**From:** Timothy Hart <thart@canal5studio.com>  
**Sent:** Wednesday, September 14, 2016 8:33 AM  
**To:** 'Sonia.barrantes@ripcordengineering.com'; Lauren Swett  
**Subject:** RE: Canal Plaza Update

**From:** Todd Dominski [mailto:tdominski@eastbrowncow.com]  
**Sent:** Wednesday, September 14, 2016 8:04 AM  
**To:** David Thomas <DThomas@consigli.com>; Timothy Hart <thart@canal5studio.com>  
**Cc:** sonia.barrantes@ripcordengineering.com; Tim Soley <tsoley@eastbrowncow.com>  
**Subject:** FW: Canal Plaza Update

**From:** Cough, Jamie [mailto:Jamie.Cough@cmpco.com]  
**Sent:** Wednesday, September 14, 2016 5:48 AM  
**To:** Todd Dominski  
**Cc:** [bhm@bhmilliken.com](mailto:bhm@bhmilliken.com)  
**Subject:** RE: Canal Plaza Update

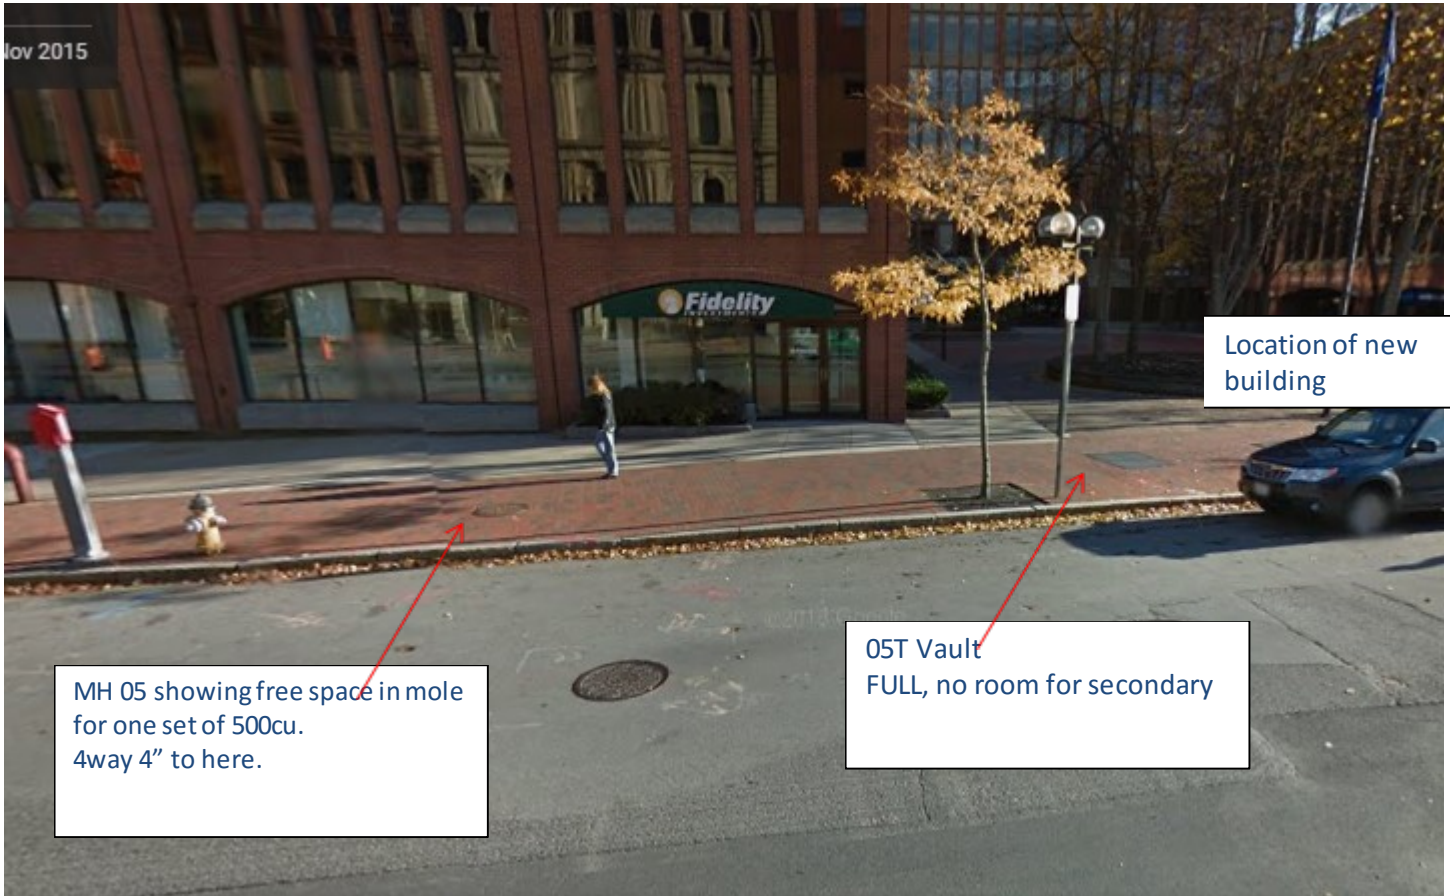
This is our tentative plan-we will confirm with our survey in the next few days.

Looking at the mole racks, we will come out of MH 05 which is directly in front of their proposed building.

The mole diagrams show space for a set of 500cu secondaries from there. That should be enough to get your team started on planning their conduit placement.

We only need one set of 500Cu, but I would suggest at least a 4-way 4" that leaves a couple spare for us, and probably one for fiber.
